Our ref: 063601-02

Re: Anambah Estate subdivision – Preliminary Assessment response – Aviation aspects

Please find in this correspondence a response to Item 8 (Aircraft Noise/ Flight Path Runway) of the Preliminary Assessment of the subject planning proposal, Maitland City Council (**Council**) reference RZ 20/001 dated 27 May 2020.

Figure 3 Upwind/final legs at Maitland Airport (01 October 2019)

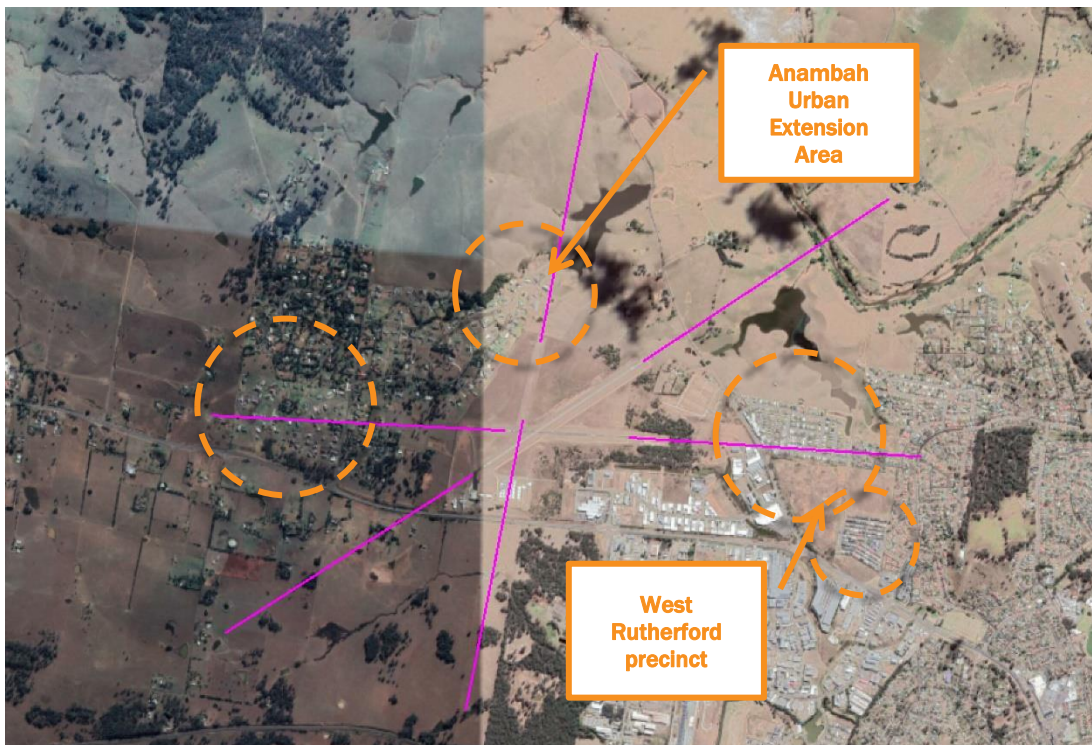
“...it is not considered good planning practice to have dwellings within an aerodrome’s take-off and landing flight path.

Council has consistently maintained this standard around the aerodrome with regard to the northeast/southwest landing strip, the east/west landing strip and the grassed north south landing strip.”

The image at Figure 3 depicts the representative 1 nm long upwind/final legs for each of the six runway ends at Maitland Airport (imagery: Google Earth, dated 01 October 2019). Note that the indicative lines are a simplistic representation and do not reflect the likely lateral and vertical variation in actual flight paths flown.

The development of dwellings in these areas is inconsistent with the suggestion that it is not considered good planning practice to have dwellings within an aerodrome's take-off and landing flight path, or that Council has consistently maintained this standard around the aerodrome with regard to the northeast/southwest landing strip, the east/west landing strip and the grassed north south landing strip.

The proposed development of the Anambah Estate is not inconsistent with Council's planning practice in relation to the location of dwellings within an aerodrome's take-off and landing flight path, given the extent of recent residential development under the flight paths associated with the other two runways.

Figure 7 Anambah Employment Area ANEC-20

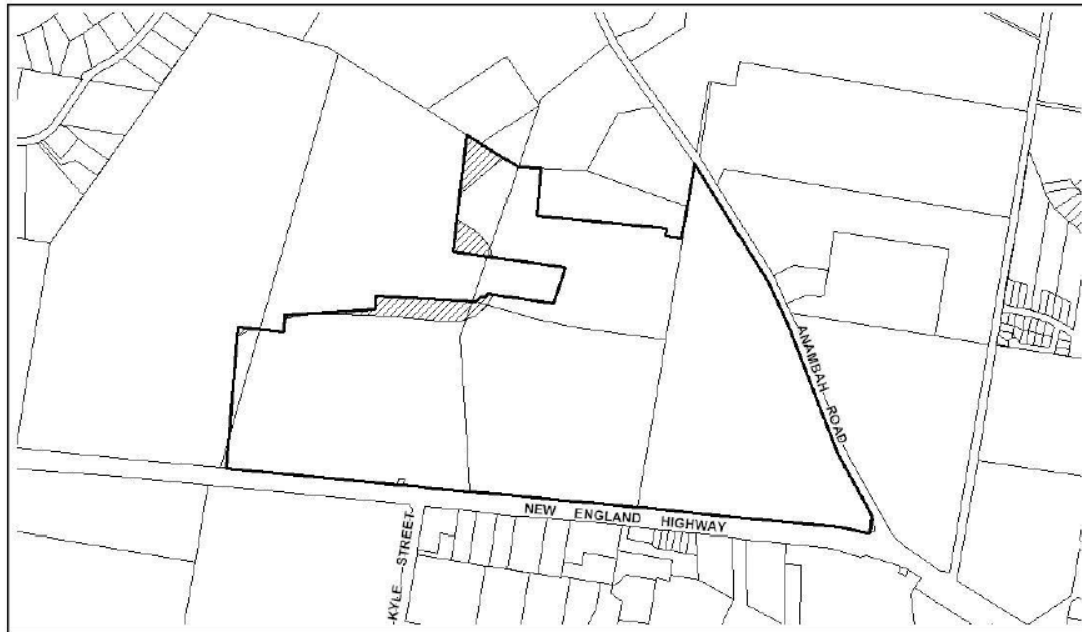
It is of concern that the noise assessment did not include aircraft takeoff as this operation generates the most noise. An additional measurement will need to be undertaken to address this and provide recommendations for noise attenuation to meet relevant inside standards.

2. Proposed uses and building design must give consideration to exposure to aircraft noise for land within the hatched area on Figure 16.

3. Buildings within this area are to be designed in accordance with the requirements of Australian Standard AS021 – Acoustics – Aircraft Noise Intrusion – Building Siting and Design.

In-situ measurement of the noise created by aircraft taking off from runway 08 may be of interest but not essential for the proper control of noise impacts over the proposed development, since it does not provide an holistic appreciation of the likely noise footprint of aircraft operations.

Spectrum Acoustics' application of ANEC contours for the control of potential aircraft noise impacts on the proposed development is consistent with commonly accepted planning practices and the use of this control in the Maitland DCP 2011.
